RE: 15605 El Gato Lane

Dear Ryan:

I reviewed the drawings, and evaluated the site context. My comments and recommendations are as follows:

Proposed Floor Plan

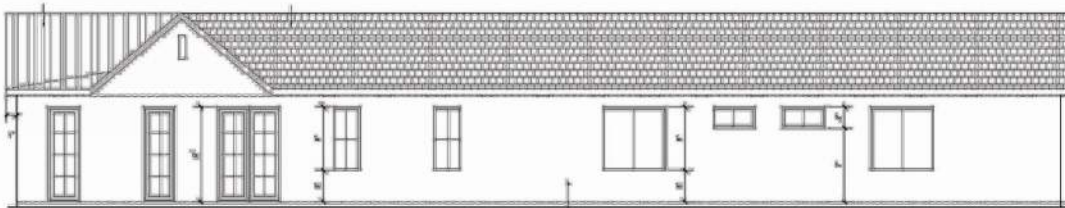
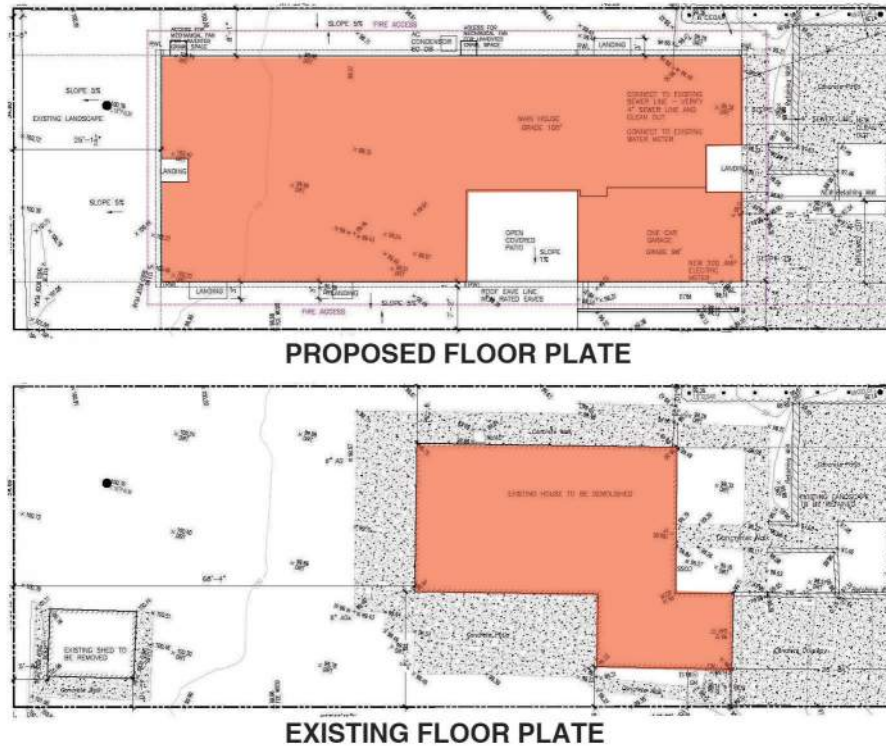
This is perhaps the primary issue or set of issues regarding this proposed design. As currently designed, the structure is a uniform rectangular box married to a front portion that is totally different in form and detail.

This window are set close to the exterior face of the wall, have minimal and non-traditional head and sill details, and lack window trim all of which are not consistent with Residential Design Guideline 3.7.4.

We have changed the roof material to composition shingle roof to match the rear roof. The accent entry roof and the metal awnings are standing seam metal roof. All windows are similar all throughout the house on all sides with similar windows / doors with true divided lights. The simplicity of the structure is to keep the house within budget for ease of construction.

We do have recessed windows on the front as the walls are 2x12, so the windows and doors will be recessed which gives the depth. The same detail is continued for all sides to give the recess for windows on side with 2x6 walls and at the doors and windows it will be 2x4.

3.2.2 Design for architectural integrity

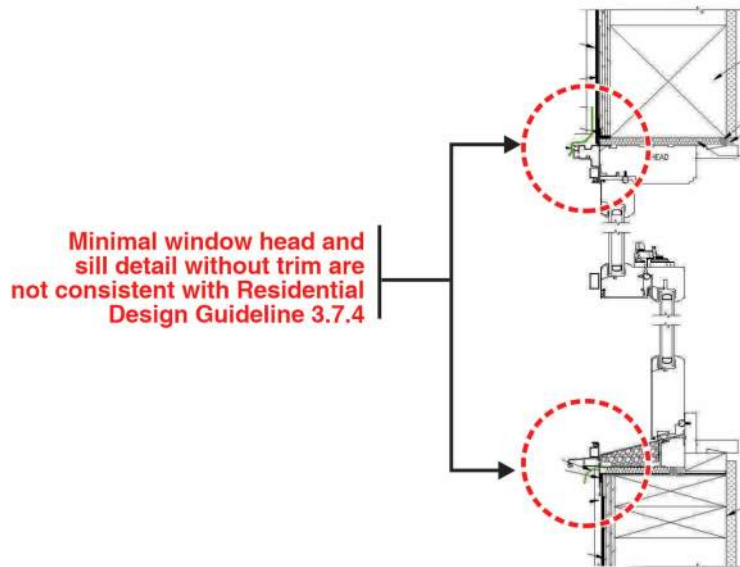
- Carry wall materials, window types and architectural details around all sides of the house. Avoid side and rear elevations that are markedly different from the front elevation.

Recommended Front Elevation

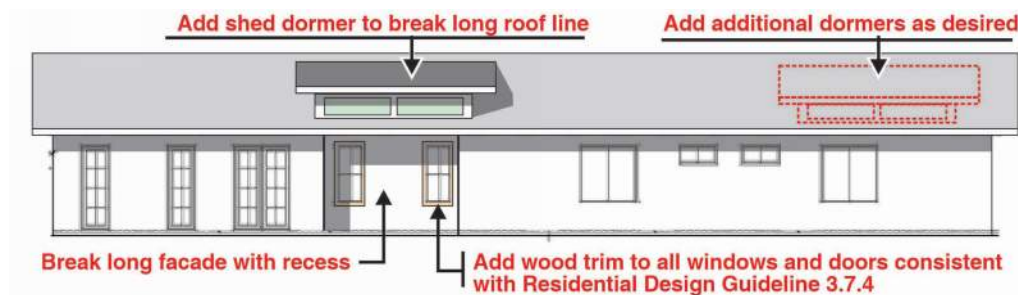
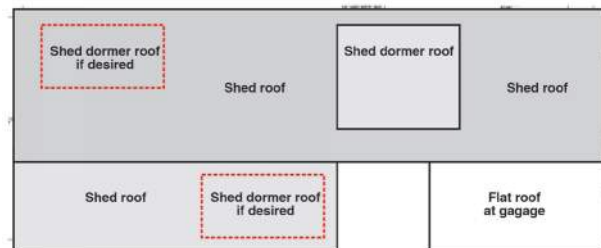
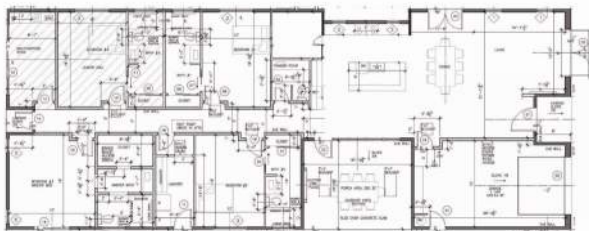
Use shed and flat roofs similar to other homes in the immediate neighborhood

Add landscaped trellis over garage

1. Change the roof forms to shed and flat or gable roofs, and eliminate metal roofing - see nearby neighborhood examples below.

2. Add trellis over garage - see photo example below.

These are old homes from the 50's which do not have any character and eventually all these homes will be rebuilt and not follow this style. With the current Title 24 requirements we want an energy efficient home where we can get more insulation in the attic rather than this form of architecture

A metal awning similar to the door in the front has been added to the garage door.

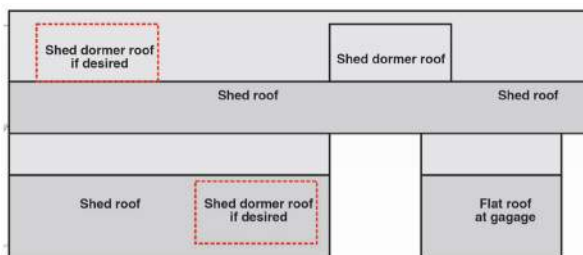
I feel that I could also recommend one other approach that I studied. It is more similar to the applicant's proposed design, but simplified in a traditional style found throughout Los Gatos. The alternate front elevation and roof plan are shown below. This alternative approach would require some minor floor plan changes.

- Moving the face of the garage back from the front facade by a minimum distance of 3 feet.
- Adjust garage recess by either reducing the depth of the garage, reducing the size of the exterior patio, reducing the dimensions of the bedrooms on this side of the house, or a combination of these adjustments to achieve the garage setback.

We would like to keep the design as shown, but accepting some suggestions by adding awnings on the sides to break the long elevation as well as added skylights also to break the roof line.

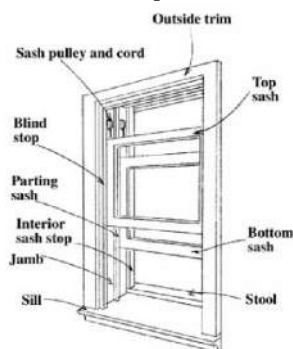
4. Add one or more roof dormers to break up long roof form

5. Utilize more traditional window details, and add wood trim at all windows and doors consistent with Residential

Design Guideline 3.7.4 -see photo example below.

As we want to keep the construction easy and at a reasonable cost we want the simplicity and have added skylights to break the roof line

As the architectural style that we are following is simple and clean and does not need wood trims as the windows are recessed
